CS Memorandum No. 1312

To: Distribution
From: Susan MacKenzie, Document Control Manager 
Date: December 18, 2012
Reference: Project No. M544.1, Contract No. CS-149
Task No. 1-8.02, Change Control
Subject: Configuration Management Board Meeting No. 103

SUBJECT: Configuration Management Board Meeting # 103– Rev. No. 0

Project No. M544.1, Contract No. CS-149
Program/Construction Management
Configuration Management Board (CMB) Meeting No. 103
November 28, 2012
3:00pm – 5:00pm
 Central Subway Project Office
 821 Howard St. 2nd Floor
 Main Conference Room

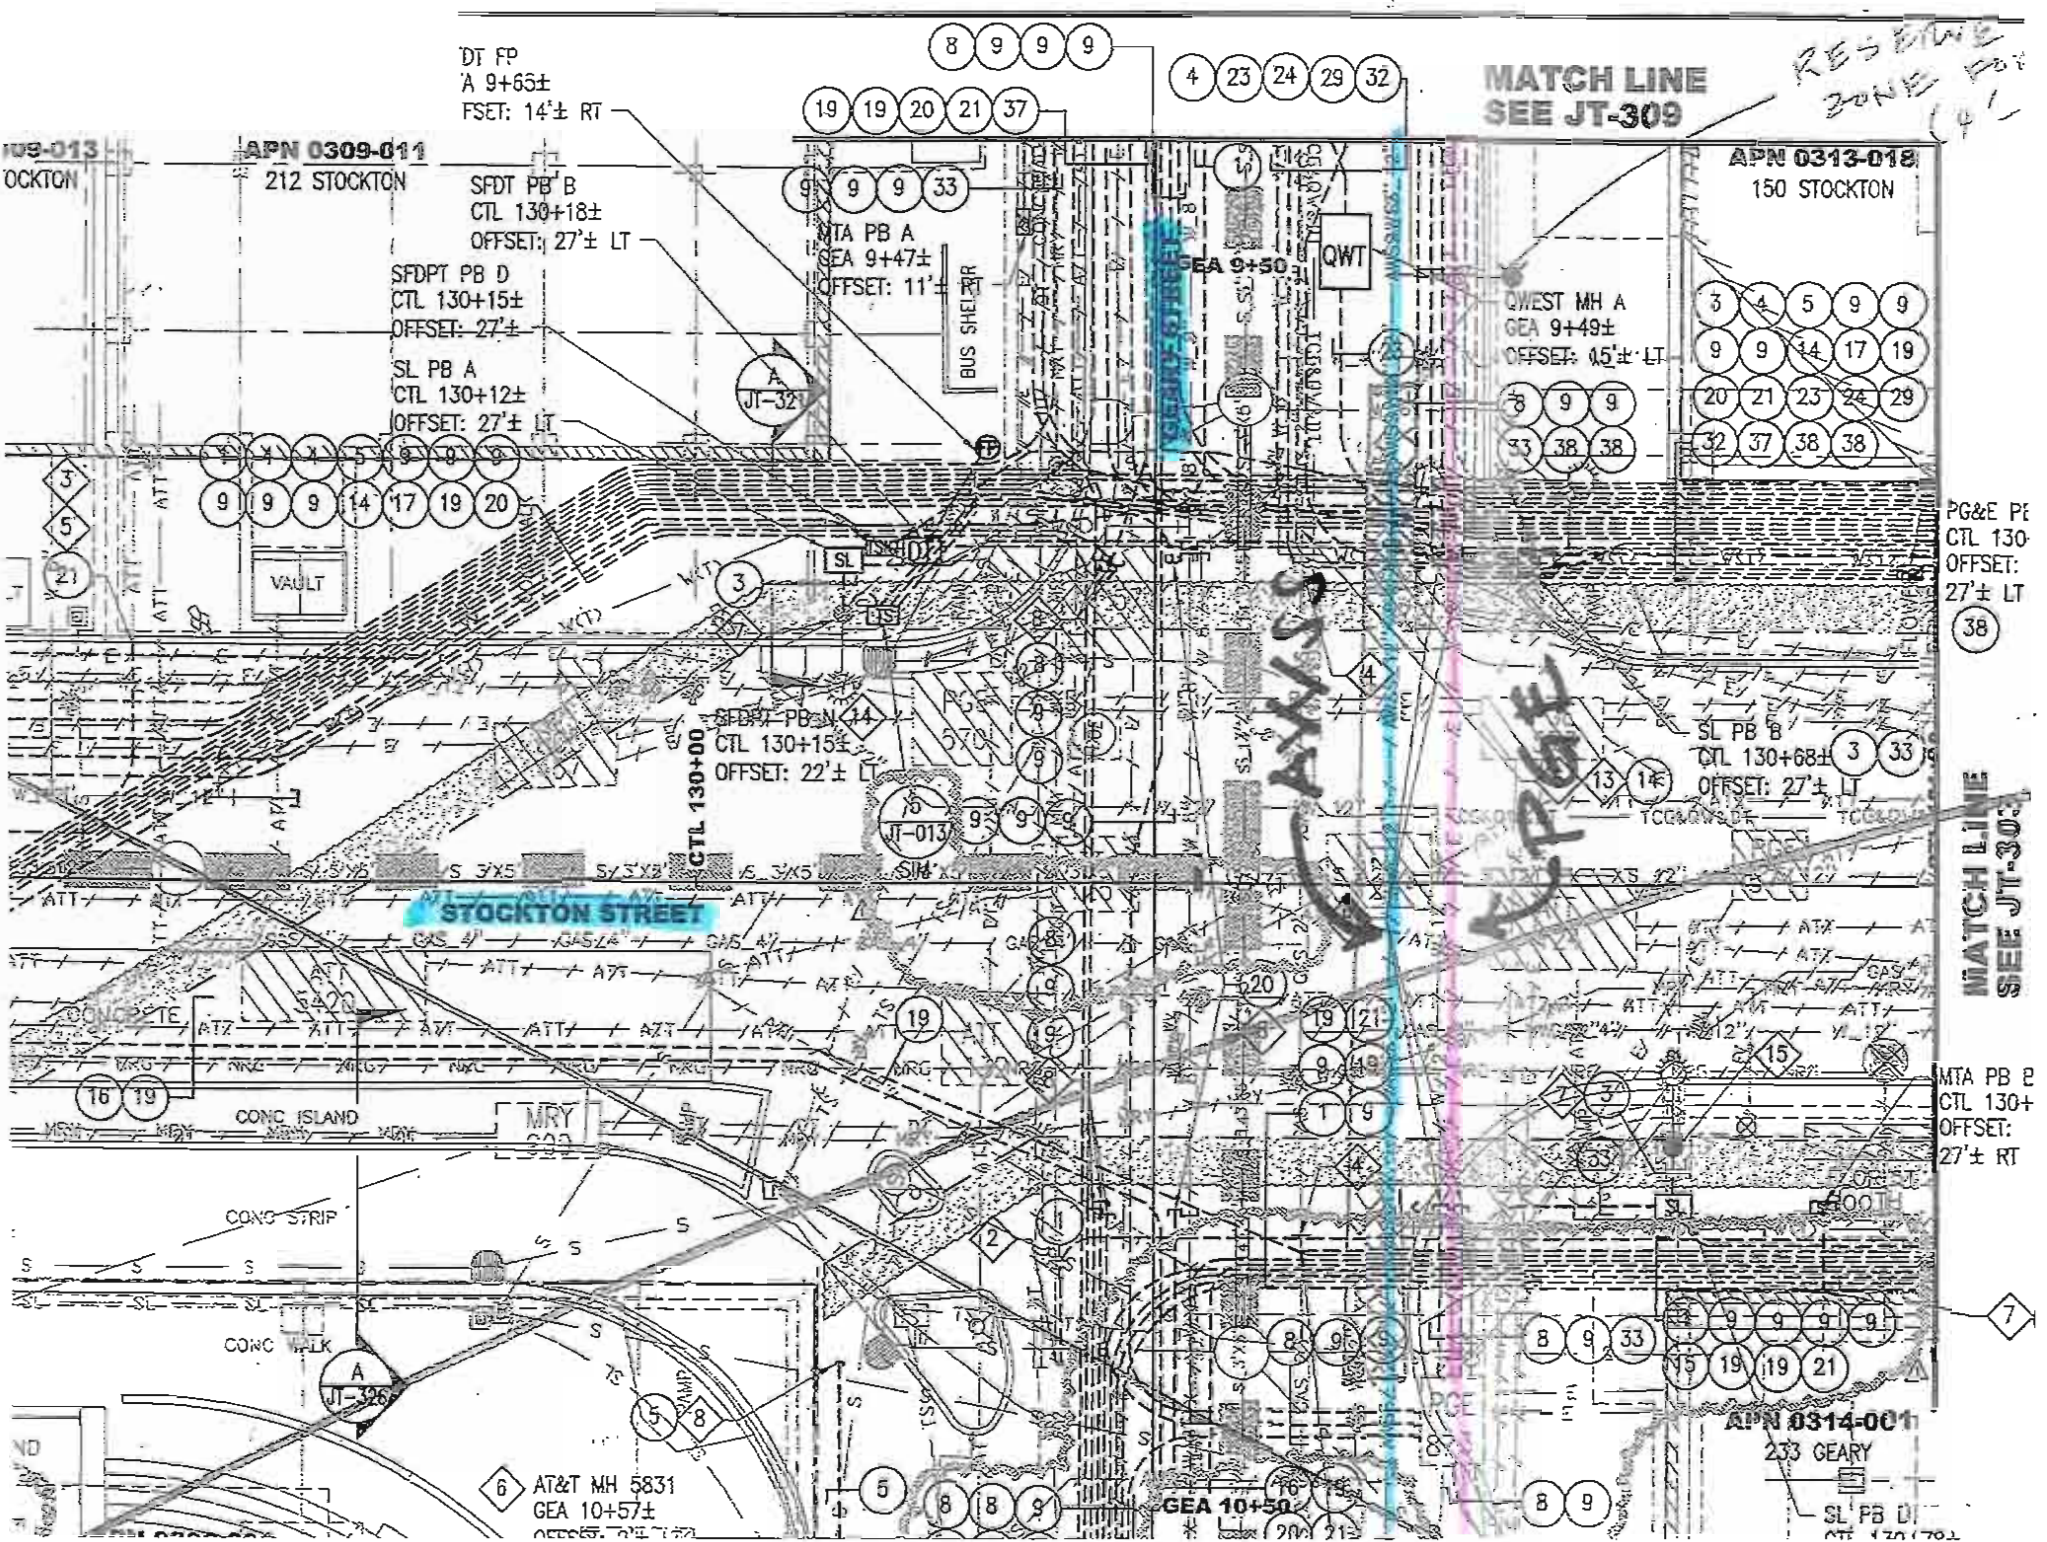
Trend 05: Contract Plans AW-501.1, 501.2, 501.4 and 501.5 show the existing AWSS to be replaced in place. However, existing PG&E conduits were found to be on top of and parallel to the existing AWSS (whereas Contract Plans JT-308 and 309 showed the existing electrical and AWSS to be in separate trenches). See attached sketch.

S:\6nas003\m544.1\FinalDesign\Drawing-821\2-Civil\Utility Demolition\Sheet Files CP03\M54423UD503.dwg FBayani Wed Jan 26,2011 - 2:41 pm UD-503

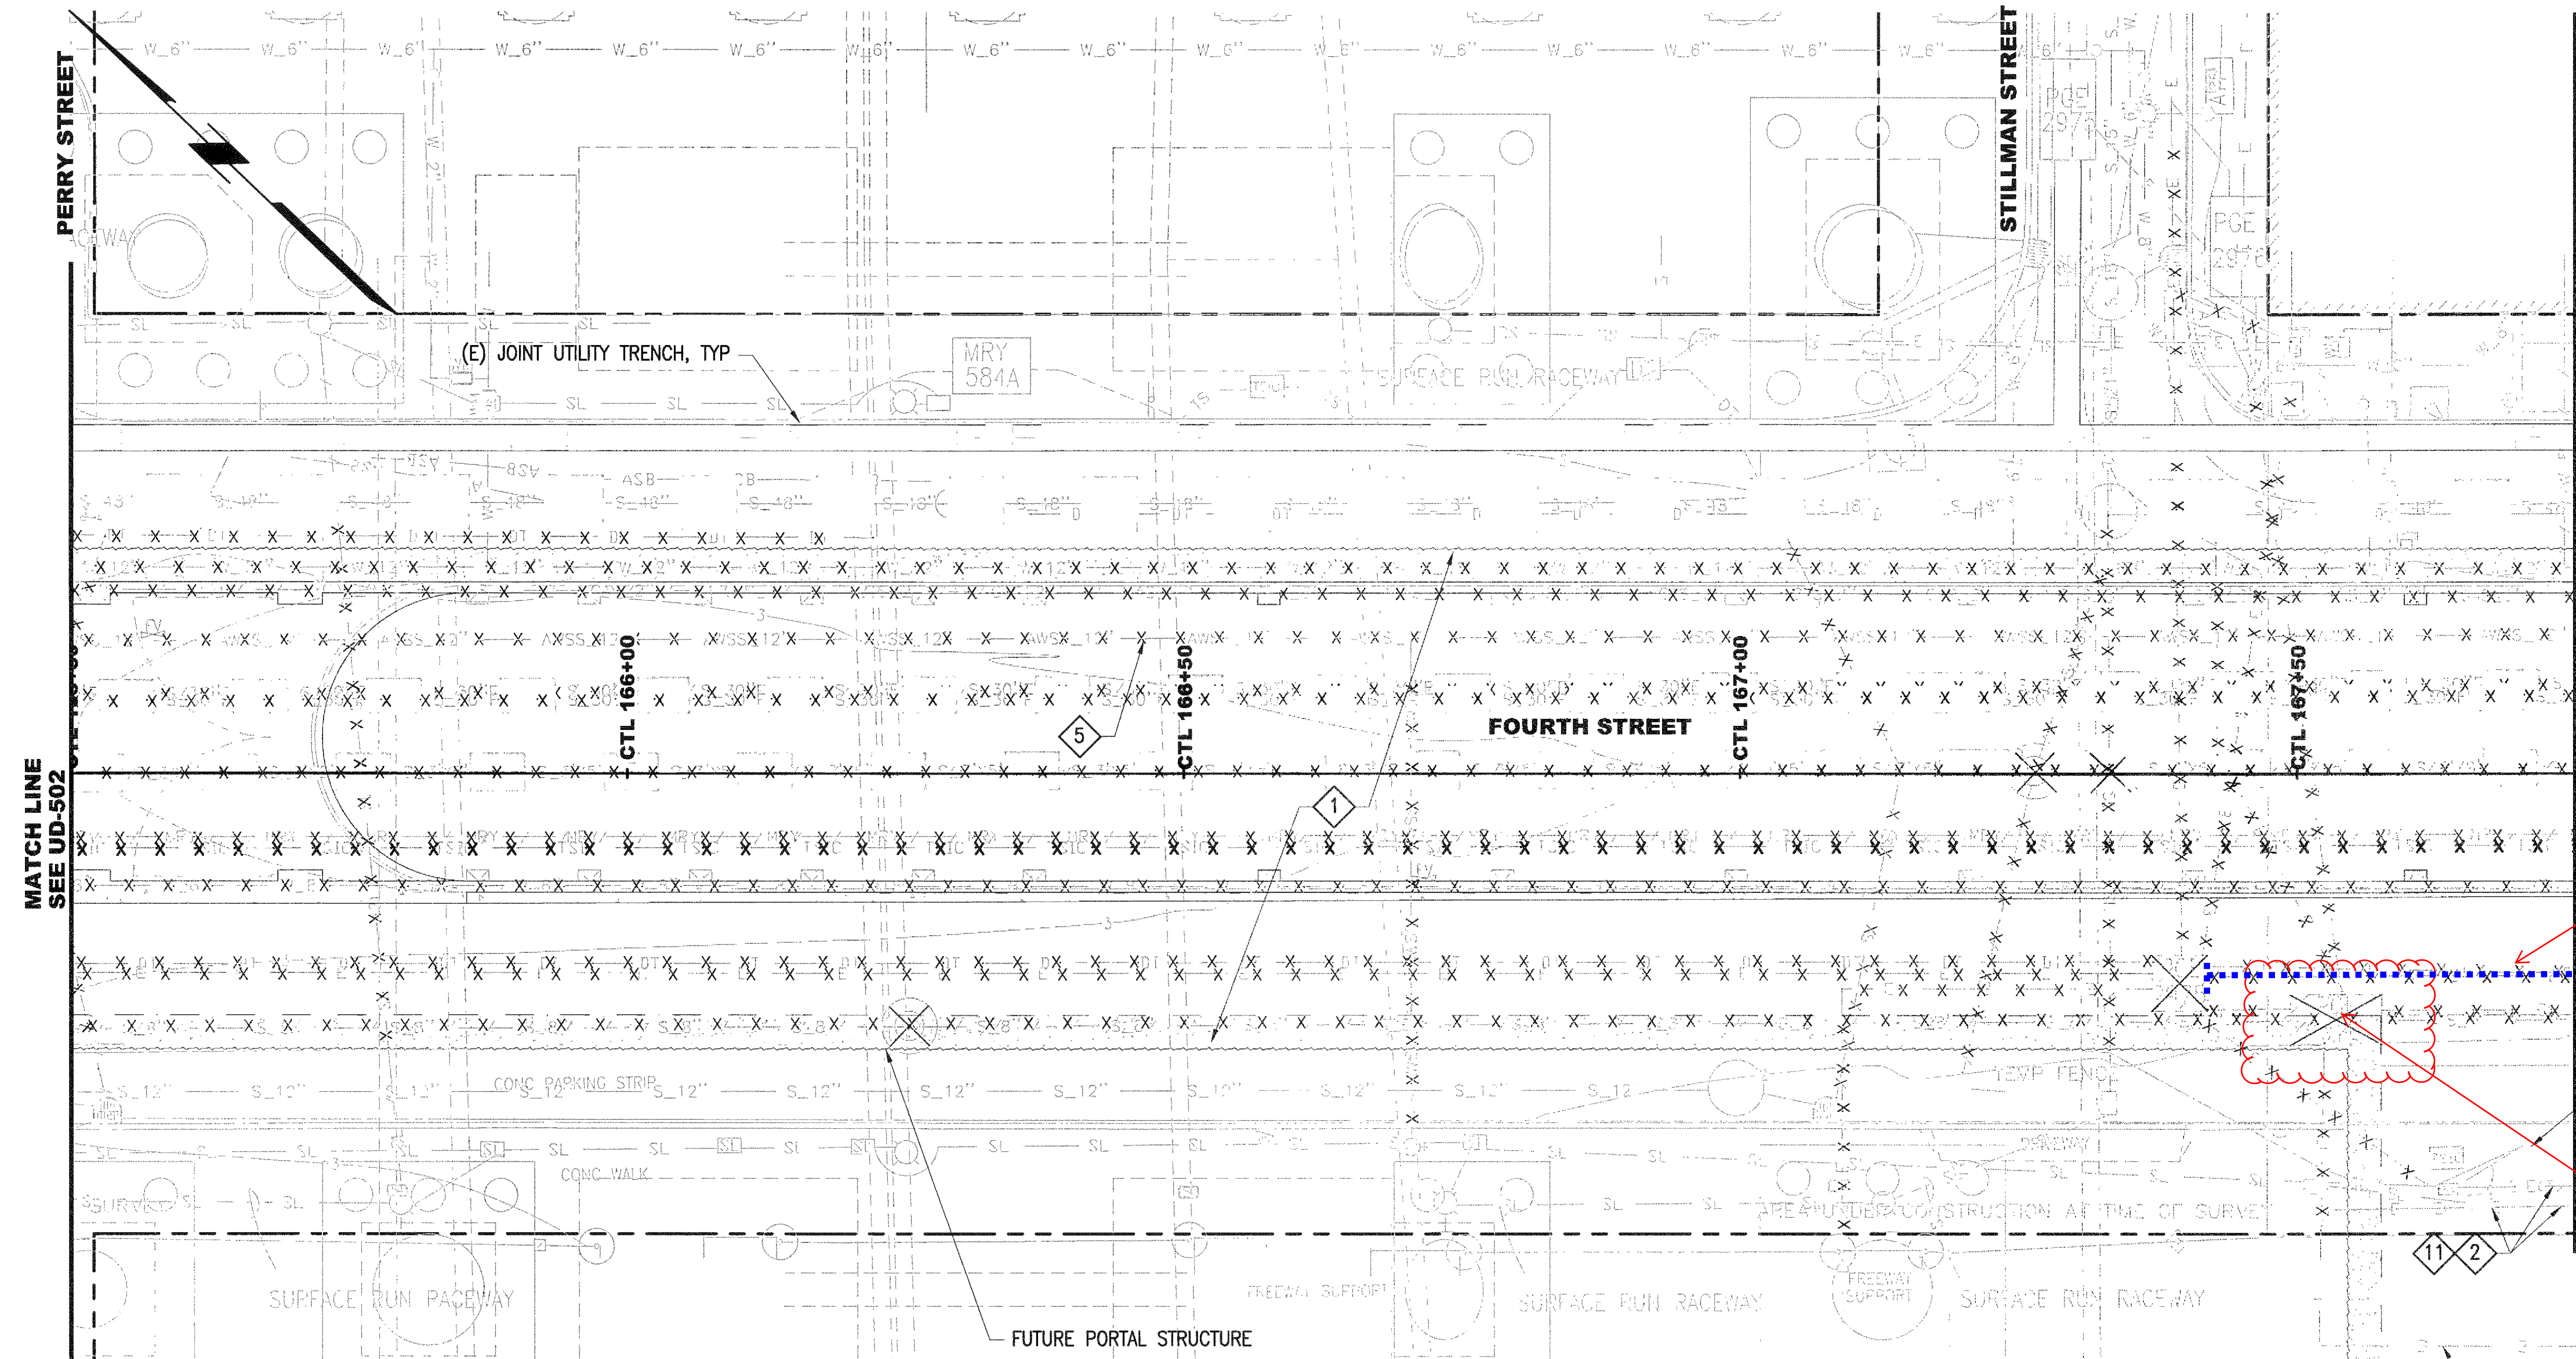
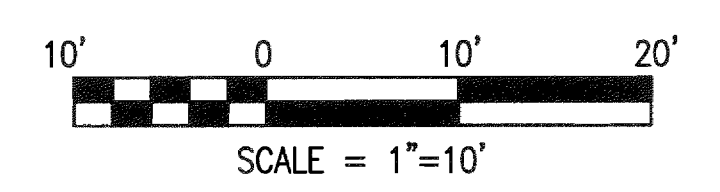
COR 006

Recommendation: Partial acceptance of Merit for COR 006. Merit shall only include additional costs for guide wall excavation and forming inefficiencies due to the presence of live PG&E utilities. Merit shall not be granted for costs associated with sewer work, which is part of the contract. The Contractor did not submit a request for time extension for this work.

Facts: In order for the completion of the Launch box guide walls to take place PG&E Vault #2975 and the utilities connected to it were required to be abandoned prior to excavation. The contract documents indicated that these utilities were abandoned; however SFMTA was informed on April 5, 2012 that PG&E Inspector Tom Reimer found live electrical and fiber optic lines when performing an inspection inside PGE Vault #2975. The de-energization of PG&E line and the SFDT cutover were not completed until May 23rd.

Justification: CJA-NCC experienced inefficiencies due to the presence of live utilities which were shown to be abandoned within the Launch box construction area. The extent and duration of the inefficiencies requires further evaluation.

Live PGE electrical leaving the 2975 Vault verified by Tom Reimer

Guide Wall Excavation location
